APPLICATION NO.	FILING DATE	FIRST NAMED INVENTOR	ATTORNEY DOCKET NO.	CONFIRMATION NO.
10/752,208	01/06/2004	Irving Sabo	2258.002	2638
23405	7590	05/09/2006		
HESLIN ROTHENBERG FARLEY & MESITI PC 5 COLUMBIA CIRCLE ALBANY, NY 12203			EXAMINER GABLER, PHILIP FRANCIS	
			ART UNIT 3637	PAPER NUMBER

Office Action Summary	Application No. 10/752,208	Applicant(s) SABO ET AL.	
	Examiner Philip Gabler	Art Unit 3637

DETAILED ACTION

**FIG. 1****FIG. 2****Exhibit 1: Brown '114 Figures 1 and 2**

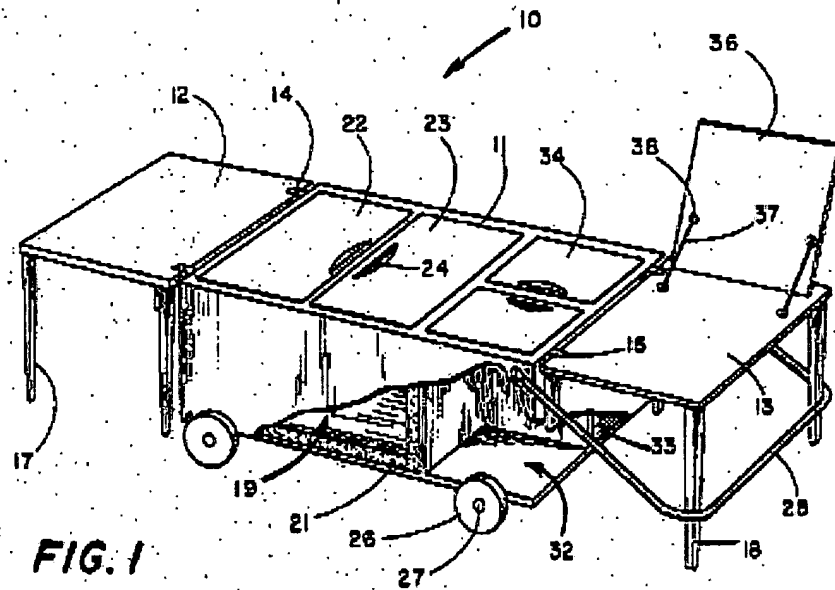
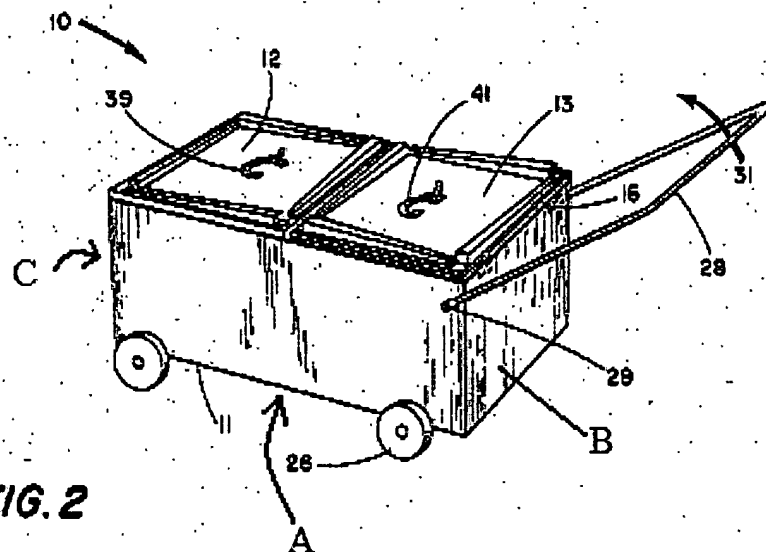
2. Claims 1-10, 32, and 33 are rejected under 35 U.S.C. 102(b) as being anticipated by Brown (US Patent Number 3873114). Brown (Figures 1 and 2) discloses a storage container comprising: an enclosure (11) having an open top (covered in Brown's figures), a bottom (viewed as A in Exhibit 1), a first end (B), and a second end (C) opposite the first end; a first lid (13) pivotally mounted to the first end, the first lid adapted to cover at least some of the open top; and at least one second lid (23) detachably mounted (as evident by the handle for allowing manipulation of the lid to gain access to the container) between the first end and the second end, the second lid adapted to cover at least some of the open top.

3. Regarding claim 2, Brown further discloses a third lid (12) pivotally mounted to the second end (C), the third lid adapted to cover at least some of the open top.

6. Regarding claim 5, Brown further discloses the first lid adaptable to be pivotally mounted into a horizontal position outside the open top of the enclosure (see Brown's Figure 1).

7. Regarding claim 6, Brown further discloses at least one of the first lid and the third lid is adapted to be pivotally mounted into a horizontal position outside the open top of the enclosure (see Brown's Figure 1).

8. Regarding claim 7, Brown further discloses the first lid is adapted to be pivotally mounted in a vertical position outside the open top of the enclosure (not only does the lid swing through a first vertical position between its closed and open horizontal positions, but, with the legs folded, it could continue to a second, downward, vertical position along the end of the container).

9. Regarding claim 8, Brown further discloses the first lid, the second lid, and the third lid are adapted to substantially enclose the open top of the enclosure.

10. Regarding claim 9, Brown further discloses at least one removable sub-container (19) positioned within the enclosure (it is view that as an insulated compartment, at least the liner could be removed).

11. Regarding claim 10, Brown further discloses a plurality of detachably mounted second lids (22), (23), (34).

12. Regarding claim 32, Brown further discloses the second lid comprises at least one liquid collector (24, which is recessed and would accordingly collect liquid).

13. Regarding claim 33, Brown further discloses the first lid and second lid are adapted to substantially enclose the open top of the enclosure (in as much as Applicant's invention does so).

Primas '399 Figures 9, 11, and 12

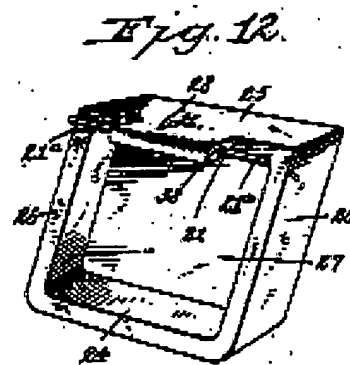
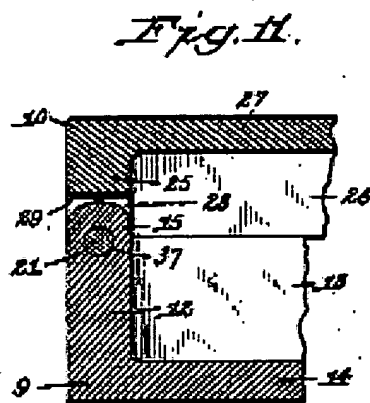
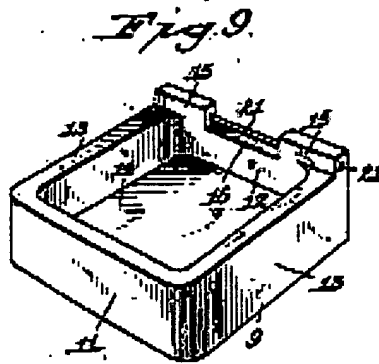
15. Claims 21-30 are rejected under 35 U.S.C. 103(a) as being unpatentable over Brown in view of Primas (US Patent Number 2200399). Brown discloses a hinge assembly (16) for use with a storage container having a lid and an end panel wherein the hinge assembly is adapted to allow rotation of the lid about an axis. Brown does not disclose a lid having a through hole, a hinge block having a through hole or a circular rod. Primas (Figures 9, 11, and 12) discloses a container with a lid (10) with a through hole (38) pivotally mounted to a housing (9) by a hinge assembly comprising: at least one hinge block (15) having a through hole (37); and a circular rod (21) adapted to engage the through hole in the block and lid, the circular rod having an axis (along length of 21); wherein the hinge assembly is adapted to allow rotation of the lid about the axis of the circular rod. Accordingly, it would have been obvious to one of ordinary skill in the art at the time the invention was made to modify Brown's hinge assembly as taught by Primas to use a lid and a hinge block with a through hole connected by a circular rod because this would provide a sturdy, simple hinge design.

17. Regarding claims 29 and 30, Brown, when modified by Primas as described above, discloses a storage container as recited in claim 21. Primas further discloses a hinge assembly wherein the at least one hinge block comprises at least two hinge blocks (two features 15) and a container lid comprising at least one notch (the gaps on either side of 28) wherein the at least one hinge block is adapted to engage the at least one notch. Accordingly, it would have been obvious to one of ordinary skill in the art at the time the invention was made to further modify Brown's hinge assembly as taught by Primas to use a hinge assembly with at least two hinge blocks and a lid with notches to engage these hinge blocks because this arrangement would provide Brown's container with an effective hinge design that remains simple to manufacture.

Branz et al. '859 Figure 1A

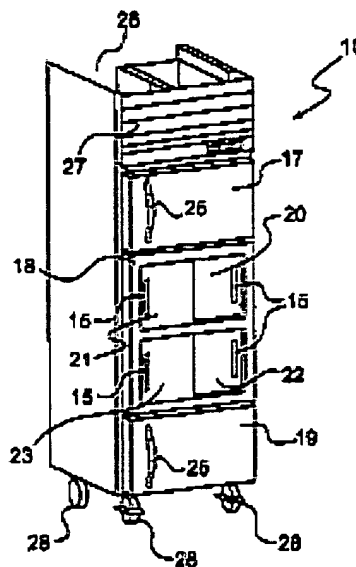
18. Claim 31 is rejected under 35 U.S.C. 103(a) as being unpatentable over Brown in view of Branz et al. (US Patent Number 6467859). Brown discloses a container as recited in claim 1 but does not disclose a slidably mounted lid. Branz (Figure 1A) discloses a storage container (10) with a slidably mounted lid (21). Accordingly, it would have been obvious to one of ordinary skill in the art at the time the invention was made to modify Brown's second lid to be slidably mounted as taught by Branz because this could allow for better temperature control of the enclosure.
